VALUE ENGINEERING STUDY

SELA Flood Control, Orleans Outfalls East Bank of Orleans Parrish, Louisiana

Final Report

DOD SERVICE: Army
VALUE ENGINEERING OFFICER: Frank Vicidomina
VE CONTROL NO.: CEMVN-VE-01-06

PROPOSED CONCEPT — SKETCH

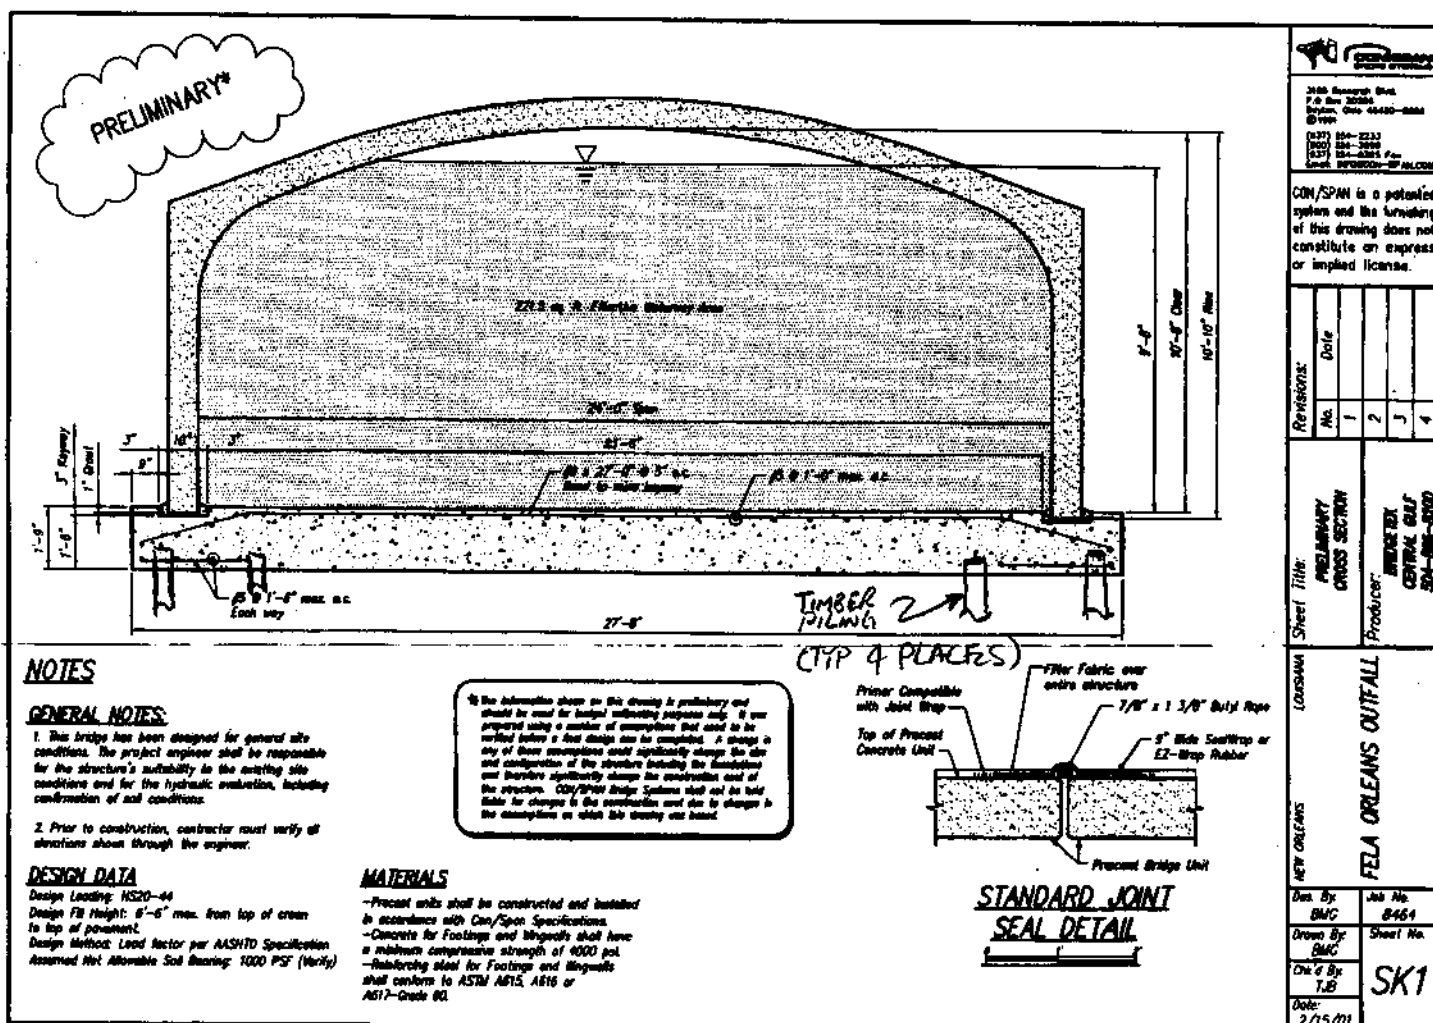
DESCRIPTION: Replace Orleans Avenue cast-in-place box culvert with arch pipe.

This type of construction is being used to build the Cousin canal in Jefferson Parish per Fritz Fromherz of Bridgetek (504-866-8200)/(504-430-5422) who is the marketing representative for Con-Span for this area. The enclosed Cousin's canal is a 36 ft span by 12.5 ft high. It was an alternative to a cast-in-place four-barrel box culvert. Mr. Fromherz indicated that this type of construction will reduce construction time by at least 25 percent. He also indicated that this type of construction would allow for a larger selection of contractors since they need only to form a base.

This proposal would be even more advantageous if accompanied by a clause in the specifications that provided incentive to the Contractor for early completion.

PROPOSED CONCEPT — SKETCH

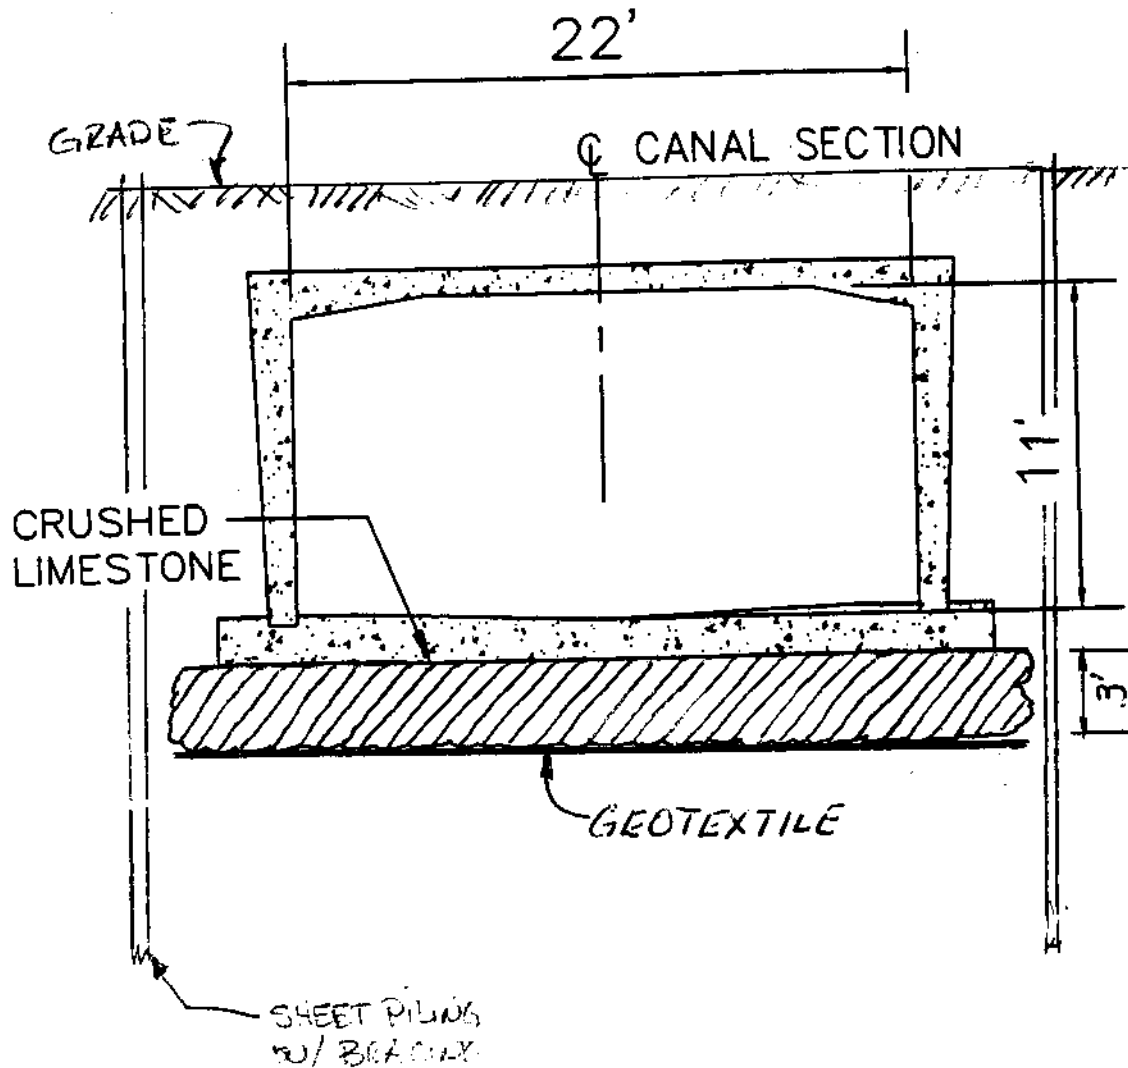
*The actual bearing pressure was later determined to be about 30% of this assumed value. To overcome this lower bearing pressure a 3-foot thick crushed rock layer was placed on a geotextile mat to increase the net bearing pressure under the slab. Prior to adopting this concept, and in-depth analysis of the design would be required.

The original concept of the 11 ft x 22 ft box culvert will resist uplift with a calculated factor of safety against uplift of 1.2. Also the calculated gross bearing pressure is less than the allowable gross bearing pressure. It is assumed that the other culverts performance will be the same.

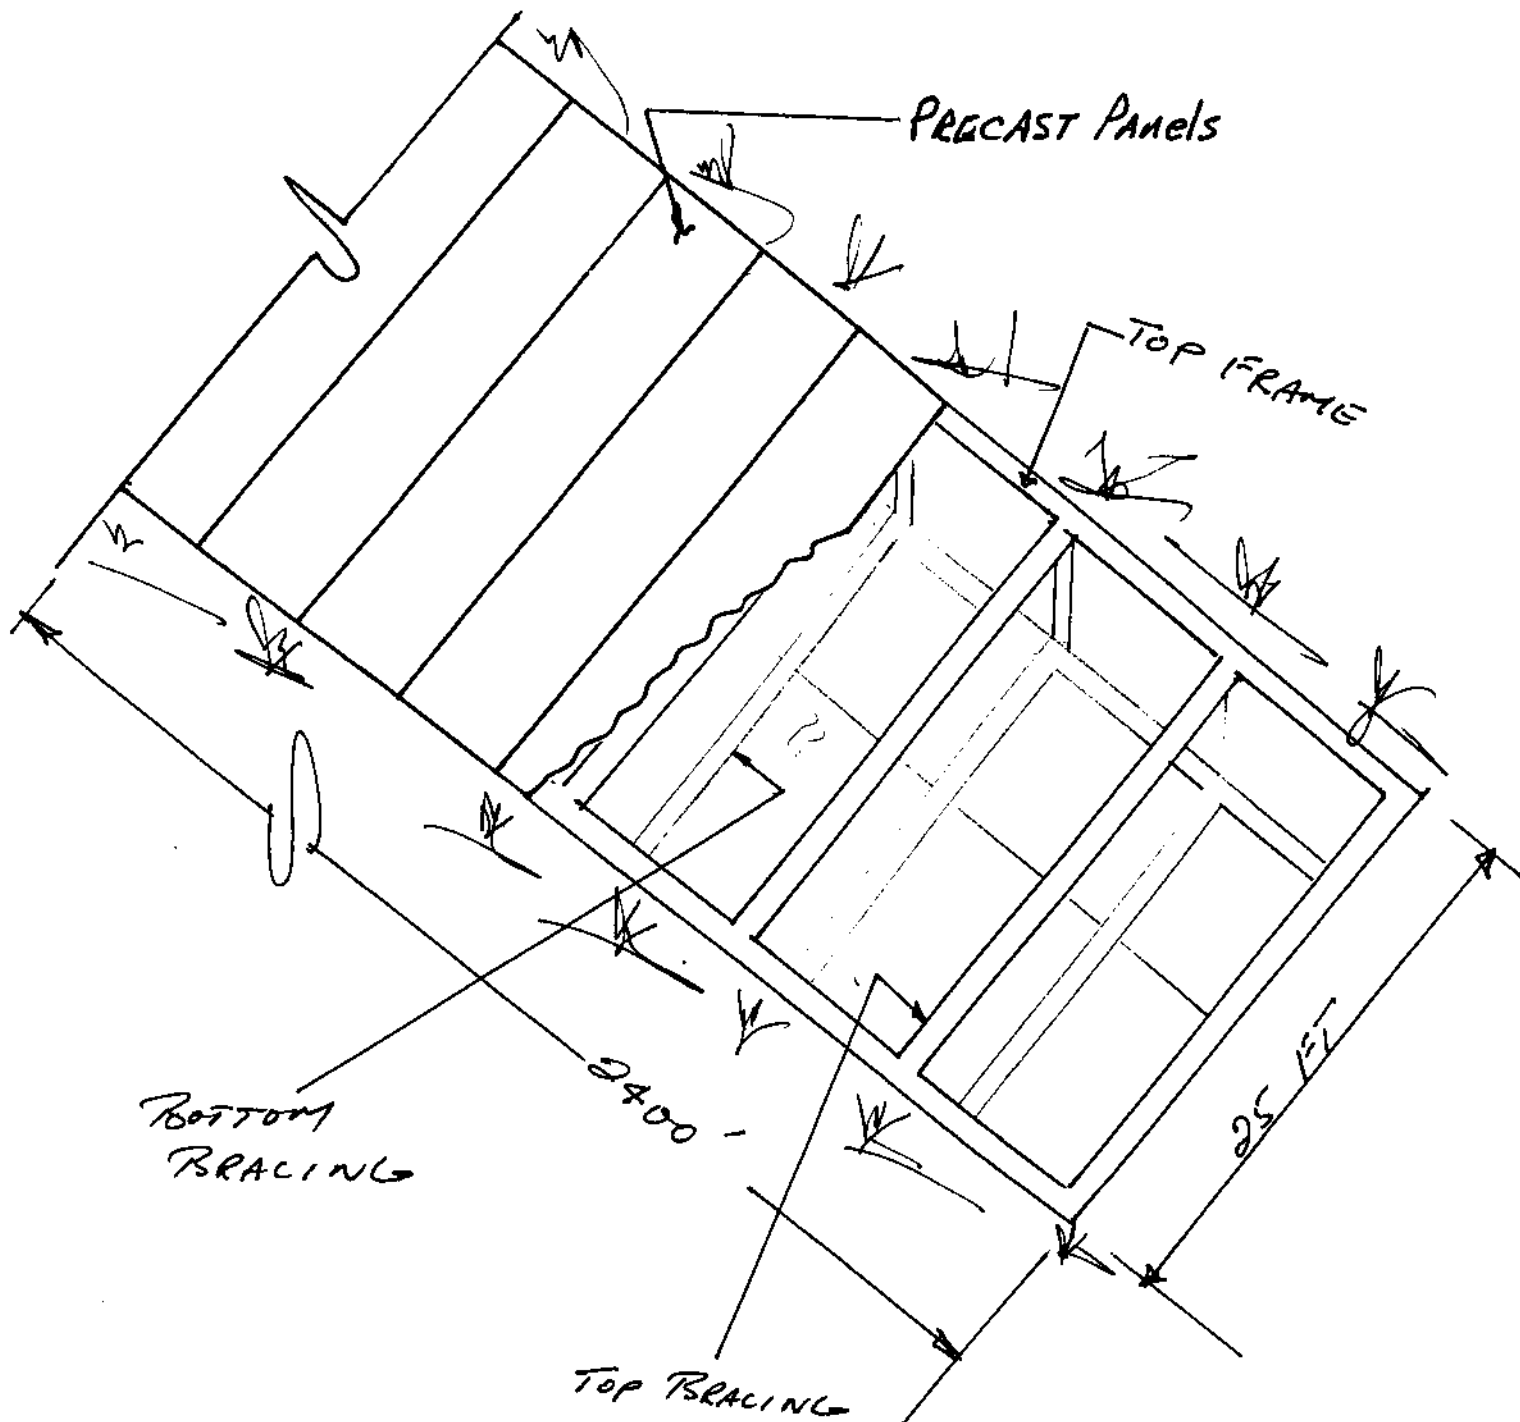
PROPOSED CONCEPT: Provide an alternative means, such as a precast fence; to both prevent water from splashing outside the canal that will also act to prevent anyone from entering the canal.

Precast panels installed across the canal will solve both concerns listed, but create some added issues. Surcharging may damage these panels, inspections are much more difficult as is maintenance. Depending on surcharge conditions, precast structural panels could be washed into the canal and create local flooding by damming the canal.

A 6-foot high precast concrete fence may not completely solve the splashing problem but it should significantly reduce the problem and present a substantial barrier to people who want to climb over the wall. When flow in the canal is large enough to cause severe splashing, conditions are more than likely to be very wet everywhere near the canal and a small amount of splashing outside the canal would not be a major concern. New Orleans is a city concerned with its appearance and an aesthetically pleasing precast concrete fence would improve the attractiveness of the canal more than horizontal precast concrete panels. Also, this approach would be less susceptible to damage from surcharging.

A 'post-less' precast fence can be constructed with gates to enable maintenance/inspection access to the canal.

TYPICAL SECTION THRU PUMPING STATION
PROPOSED CONCEPT (ROBERT E. LEE)

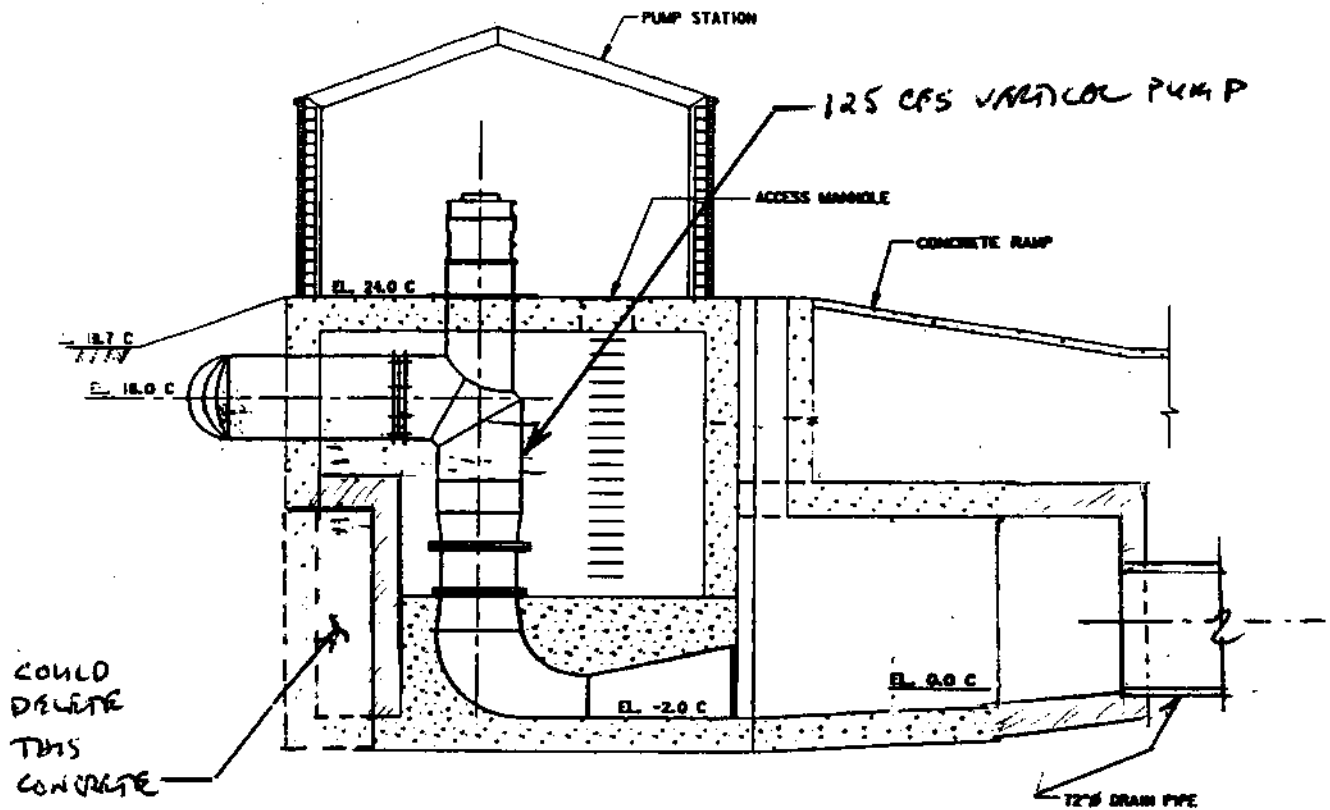
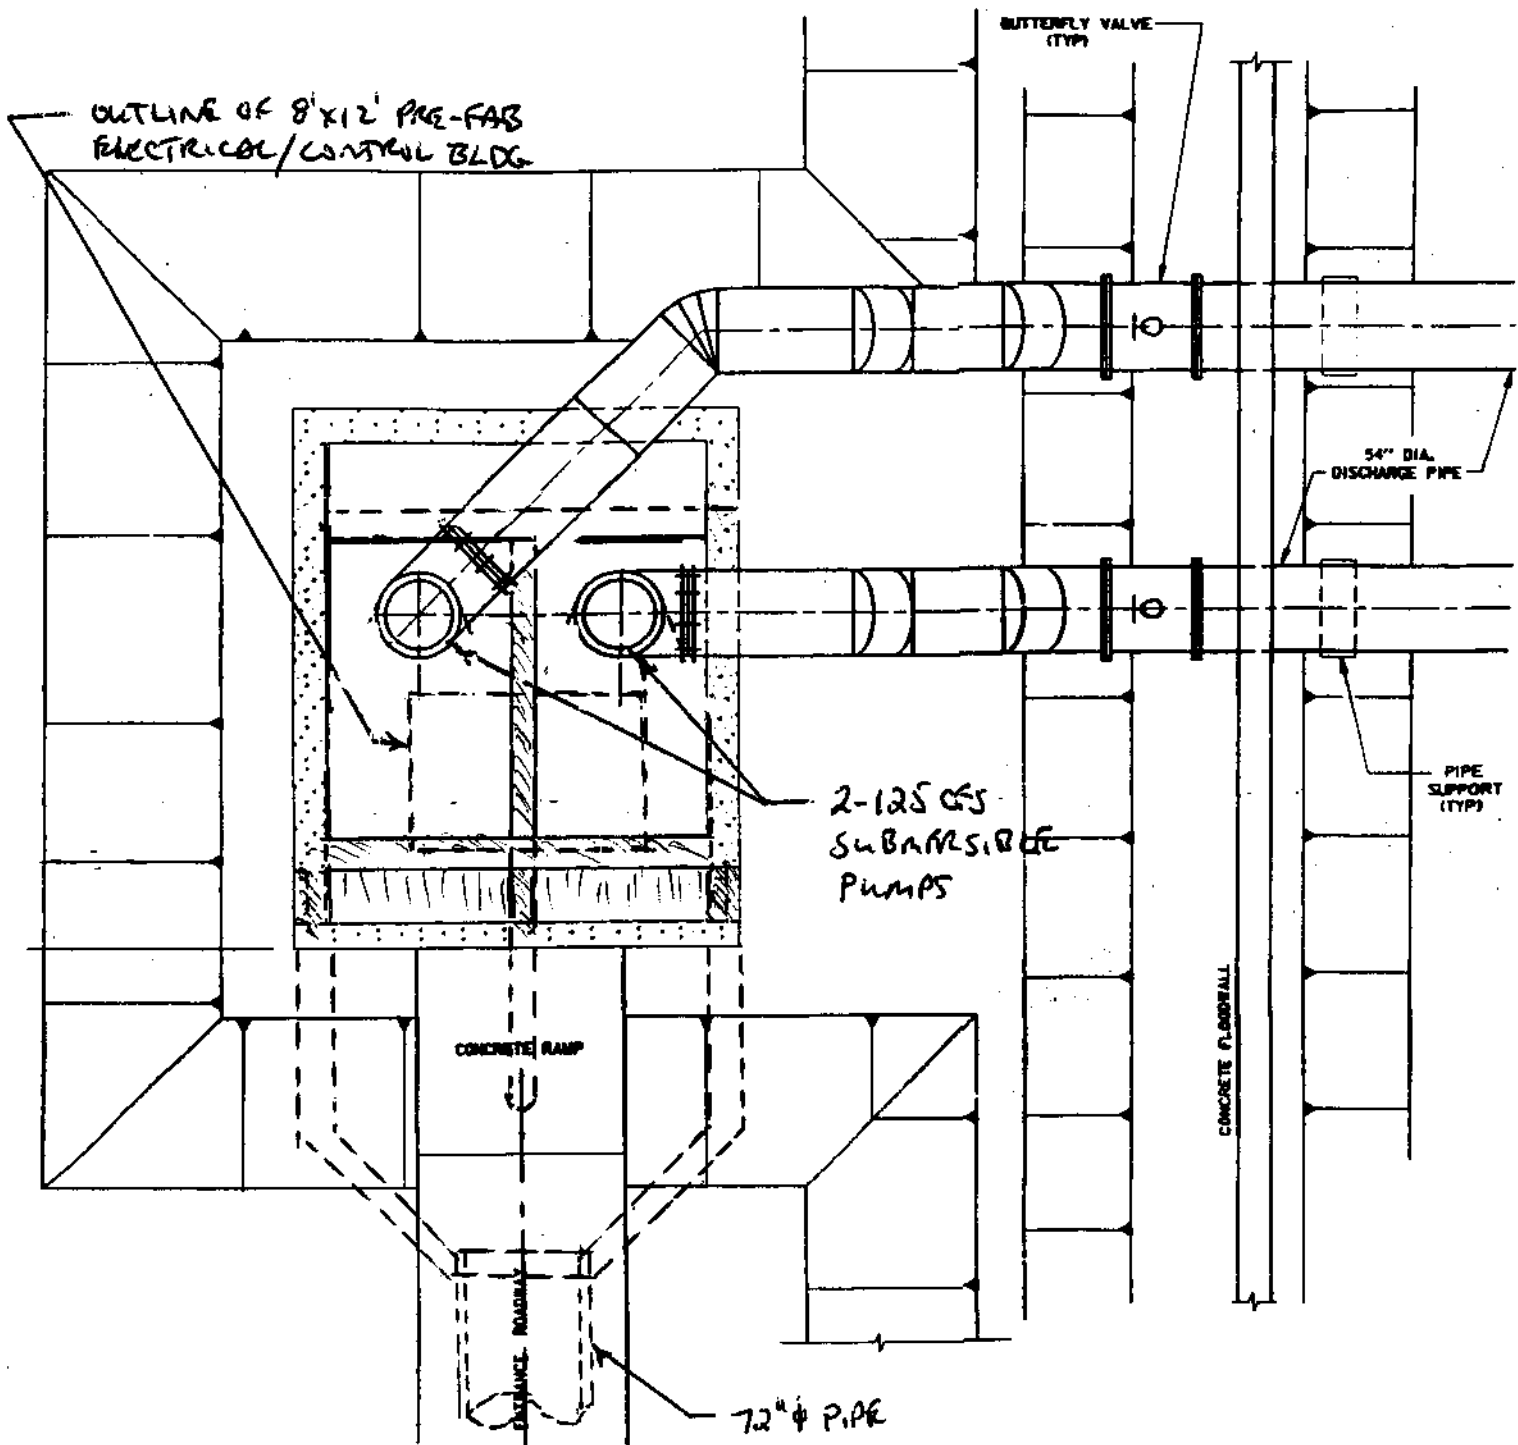
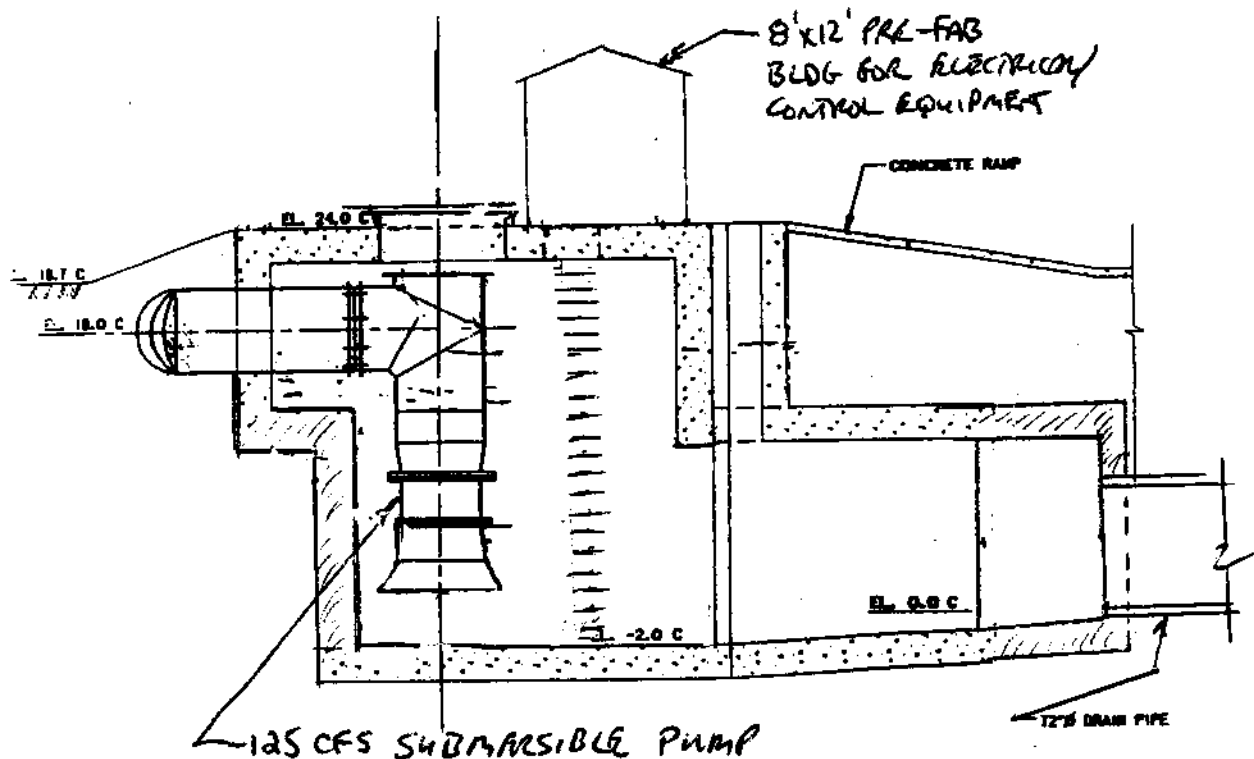
DESCRIPTION: Replace Vertical Pumps with Submersible Pumps

- Local sponsor has strong negative opinions about the O&M of submersible pumps.
- Will require a small housing unit for electrical/control equipment because superstructure has been deleted.
- Pump and motor must be generally removed for maintenance.
- The plan dimension of the pump station may be larger to allow for a properly designed wetwell. This increase in the plan dimension would increase the excavation, backfill, and the substructure concrete quantities.

The proposed concept does not require a superstructure and the cost for this item can be deleted from the proposed concept.

The other major cost item is the installed cost of the two different types of pumps, but the differential is minimal.

PROPOSED CONCEPT — SKETCH

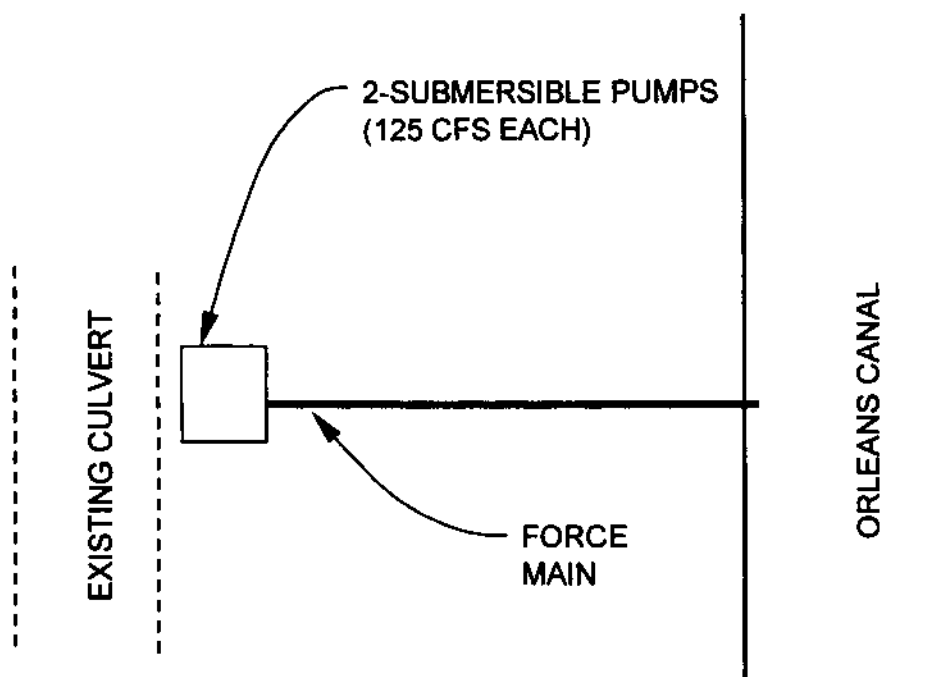
The size of the pipeline to the Robert E. Lee Pump Station is too small for the Original Concept. The pipe should have been approximately a 9-foot diameter pipe instead of the 6-foot diameter pipe. The costs for the 9-foot diameter pipe were determined by the ratio of the cost of the 6-foot diameter pipe to the 9-foot diameter pipe. The backfill and excavation quantities were determined similarly. It should also be noted that the 6 ft diameter pipe for the gravity flow original is slightly undersized and the correct size is closer to 6.5 feet in diameter. However, for purposes of this preliminary evaluation, using a 6-foot diameter pipe is sufficiently accurate.

Use of hydraulic driven pumps may also be practical for this application (See Data in Appendix G.) Hydraulically driven pumping systems are more expensive than conventionally driven systems; however, hydraulic systems allow the equipment/drives to be located several hundred feet from the pumping unit.

Life cycle costs for the two concepts were determined to be nearly equal. Submersible pumps are more costly to maintain, but there is little in the way of a superstructure to maintain. The 9-foot diameter gravity line for the Original Concept would be more costly to maintain than a 6-foot diameter force main due to its larger size and the possibility of concrete corrosion.
